Shearwater Perdix 2 และ Petrel 3 Firmware Release Notes

VERSION 91 2022-06-01

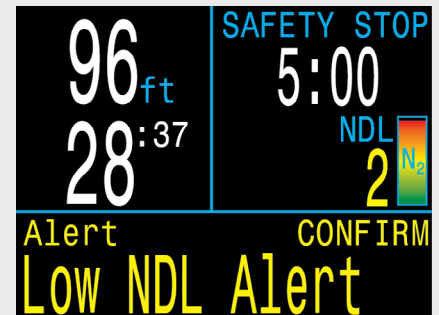
มีการเพิ่มระบบการแจ้งเตือนแบบสั่น

การสั่นจะเกิดขึ้นทุก 10 วินาที เมื่อมีข้อความคำเตือน ข้อผิดพลาด หรือสัญญาณเตือนปรากฏอยู่ที่แถวล่างของหน้าจอ เมื่อล้างข้อความโดยการกดปุ่มแล้ว การสั่นจะหยุดลง แม้สภาพการณ์ที่กระตุ้นเปิดการสั่นนั้นยังคงอยู่ก็ตาม สัญญาณเตือน PPO ต่ำและสูงจาก PPO2 (CCR) ที่ควบคุมจากภายนอกเป็นข้อยกเว้นของกฎนี้ (โปรดดูด้านล่าง) สามารถปิดใช้งานระบบสั่นได้

หมายเหตุ: แบตเตอรี่ประเภทลิเธียม 1.5V และลิเธียมไอออน 3.7V เท่านั้นที่รองรับระบบสั่นนี้ แบตเตอรี่ประเภทอื่นขาดพลังงานขาออกที่มากพอสำหรับมอเตอร์ระบบสั่น อย่าพยายามหลอกนาฬิกาดำน้ำให้เปิดใช้งานระบบสั่น โดยการตั้งประเภทแบตเตอรี่ที่ไม่ตรงตามความเป็นจริง การทำเช่นนั้นจะทำให้เกจแบตเตอรี่ไม่ถูกต้อง และอาจมีการปิดเครื่องโดยไม่คาดคิด

มีการเพิ่มระบบการแจ้งเตือนแบบสั่นทุกครั้งที่แสดงสัญญาณเตือน คำเตือน หรือข้อผิดพลาด

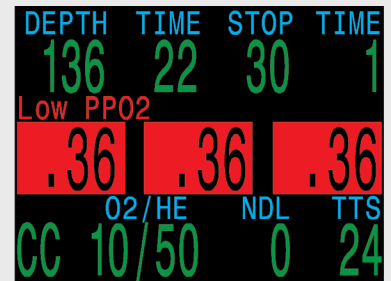
เพิ่มสัญญาณเตือนที่สั้นต่อเนื่องสำหรับ PPO2 ต่ำและสูงที่ควบคุมจากภายนอก (CCR)

เนื่องจากระดับ PPO2 มีความสำคัญอย่างยิ่งใน Closed-circuit Rebreather สัญญาณเตือน PPO2 ที่ควบคุมจากภายนอกจะสั้นต่อเนื่องทุก 10 วินาที แม้ว่าจะมีการรับรู้ข้อความแล้ว トラบเท่าที่สภาพการณ์ของสัญญาณเตือนนั้นยังคงอยู่

ตัวเลือก “Pause PPO2 Vib.” (พักการสั้น PPO2) จะมีตัวเลือกเมนูที่ใช้ได้เมื่อมีสภาพการณ์ที่กระตุ้นเปิดสัญญาณเตือนแบบสั้นสำหรับ PPO2 ตัวเลือกนี้จะหยุดสัญญาณเตือนแบบสั้นสำหรับ PPO2 ชั่วคราวเป็นเวลา 5 (ห้า) นาที ในช่วงเวลานี้ สภาพการณ์สำหรับการแจ้งเตือนอื่น ๆ จะยังคงกระตุ้นเปิดการสั้นได้

เมื่ออยู่ในโหมด BO จะไม่กระตุ้นเปิดสัญญาณเตือนแบบสั้น (เนื่องจากค่า PPO2 ได้มาจากก๊าซ Bailout สำหรับ Open Circuit)

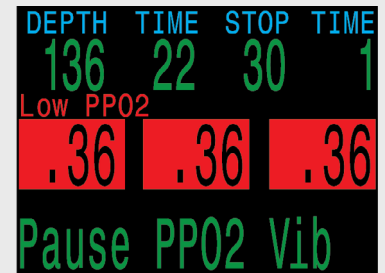
เมื่อมีสัญญาณเตือน PPO2 ภายนอกต่ำหรือสูง สัญญาณเตือนแบบสั้นจะดำเนินต่อแม้จะเคลียร์ข้อความคำเตือนแล้ว

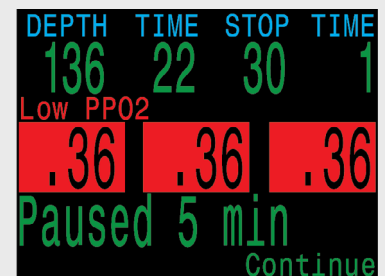
เมื่อระบบสั้นทำงานอยู่ จะมีตัวเลือกเมนูที่ใช้เพื่อพักการสั้น PPO2 ได้

ตัวเลือกนี้จะหยุดการสั้นชั่วคราวเป็นเวลา 5 นาที

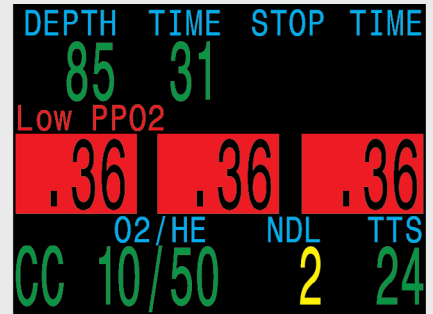
รองรับฮาร์ดแวร์ Petrel 3 พร้อมหน้าจอแสดงผล AMOLED ขนาด 2.6 นิ้ว
สีตั้งต้นของหน้าจอ AMOLED คือสีเขียว ไม่สามารถเลือกสีขาวเป็นสีหลักได้

จอ AMOLED ของ Petrel 3 มีสีสดใส
และมีขนาดใหญ่กว่าที่ 2.6 นิ้ว

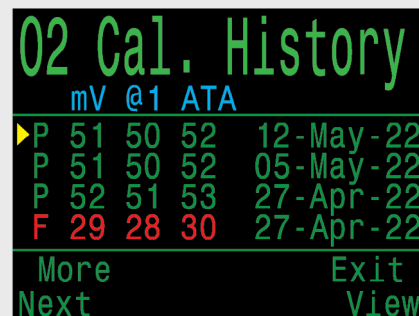
แสดงประวัติการปรับเทียบ PPO2 เบราร์เซอร์บันทึกจะแสดงวันที่ สถานะ ระดับมิลลิโวลต์ (mV) และพารามิเตอร์ขาเข้าสำหรับการปรับเทียบ PPO2 ทั้งหมด

โปรดทราบว่าระดับ mV จะแสดงในเบราร์เซอร์ประวัติตามที่เกิดขึ้นเมื่อ PPO2 อยู่ที่ 1.0 ata ซึ่งทำให้สามารถเปรียบเทียบการปรับเทียบในสภาพการณ์ที่แตกต่างกันได้ ยกตัวอย่างเช่น มีการปรับเทียบด้วยก๊าซปรับเทียบ FO2 100% และแรงดันโดยรอบ 1.0 ata (จึงเป็น PPO2 ของ 1.0 ata) โดยผลที่วัดได้คือ 50 mV เซนเซอร์เดียวกันนี้ หากปรับเทียบด้วย FO2 100% ที่ระดับความสูงที่สอดคล้องกับแรงดันโดยรอบ 0.90 ata (PPO2 ของ 0.90 ata) จะให้พลังงานเพียง 45mV ในเบราร์เซอร์ประวัติ การปรับเทียบทั้งสองครั้งจะแสดงเป็น 50mV เพื่อให้สามารถเปรียบเทียบสถานะ เซนเซอร์ได้โดยตรง หากดูรายละเอียด ค่า mV จริงตอนปรับเทียบจะแสดงด้วย

การปรับเทียบ PPO2 ที่ไม่ต้องการจะถูกลบจากบันทึก

สามารถเข้าถึง “O2 Cal. History” (ประวัติการปรับเทียบ O2) ได้จากเมนู Dive Log (บันทึกการดำน้ำ) หรือเมนู System Setup (การตั้งค่าระบบ) -> O2 Setup menu (เมนูการตั้งค่า O2)

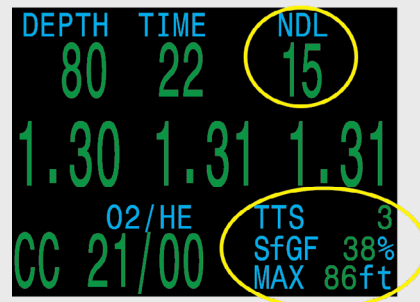
สามารถเลือกหน้าจอ MINI สำหรับการ
ตั้งค่า NDL ได้

ตัวเลือกนี้จะเลื่อน NDL ขึ้นไปที่ตำแหน่ง
DECO STOP เมื่อต้องมีการพักเพื่อลด
ความกดอากาศ ค่านี้จะมาแทนที่ NDL

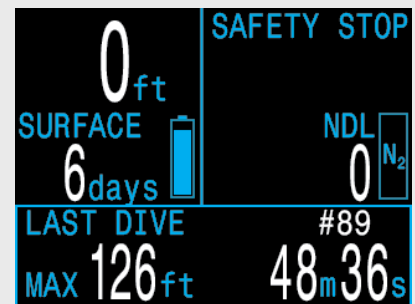
Added user configurable “Alerts”. These can be programmed to provide a warning when specified limit is reached. Also, the applicable display on the main screen will change to yellow while limit is exceeded. On the Peregrine, the vibration will activate with the warning.

The “Vibration” setting is only available on the Peregrine. Other models are visual alerts only.

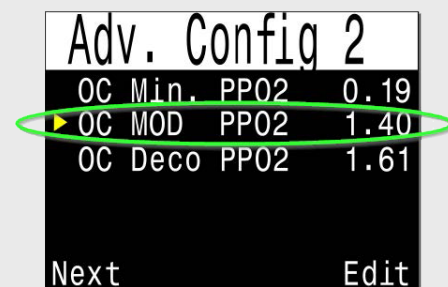
Previously, there was an “OC Max PPO2” setting which only defined when the “High PPO2” message occurred, regardless of dive phase (e.g. bottom depth or at deco stop). This confused many users who, quite reasonably, assumed it was the “bottom depth” limit and set it to 1.40. This would result in warnings during deco when the PPO2 was pushed to the 1.60 range.

The “OC Max PPO2” has now been removed and replaced with a “OC MOD PPO2” setting. The MOD setting only applies to the bottom depth phase. The dive computer automatically switches to using the “OC Deco PPO2” limit when within 2 stops of the next deco stop. The “OC Deco PPO2” limit also sets where predictive deco gas switches occur. Also, if the current gas has greater than or equal to 80% oxygen fraction, then the deco limit is used, as the gas is assumed to be a deco gas.

The tissues bar graph is now shown on the Tissues Restored screen

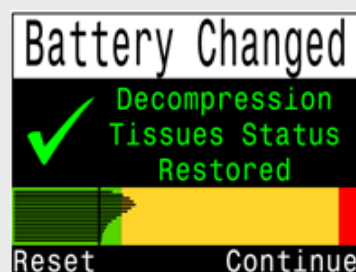
NEW On the Tissues Restored screen, a shortcut to reset the tissues is given. If Reset is chosen, a prompt will be displayed to confirm. **Do NOT reset tissues between repetitive dives, as inert gas loading will be lost.**

The mark heading command now requires less button presses

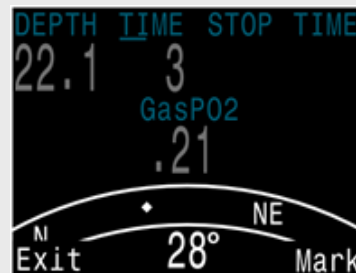
CHANGE Compass mark heading menu moved to reduce button presses. Also, the compass can now be viewed while marking. Operation: when viewing compass a left button press brings up an "Exit/Mark" menu. Right press marks compass, Left press exits to main screen. Previously had to navigate to regular menus to mark the compass.

The offset between current and marked heading is now shown (in this example 16°)

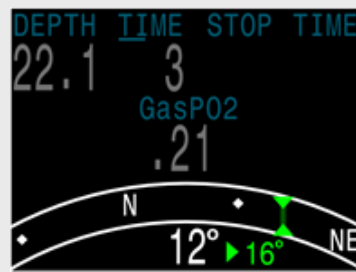
IMPROVE When a heading is marked, the display now shows the offset angle between the current heading and the marked heading. This is useful for navigating patterns. For example, a box pattern requires turns at 90° intervals, while a triangle pattern requires turns at 120° intervals.

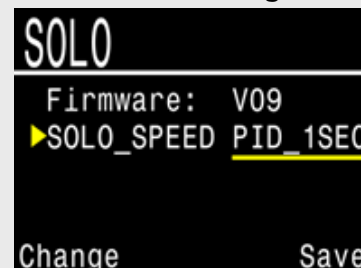
NEW Added support for changing settings on peripheral boards.

For example, on the SOLO board (solenoid and oxygen controller) the Solenoid Speed setting can be adjusted. Go to “Bus Devices” page on Petrel to access peripheral boards. Settings viewed here are stored on the peripheral device.
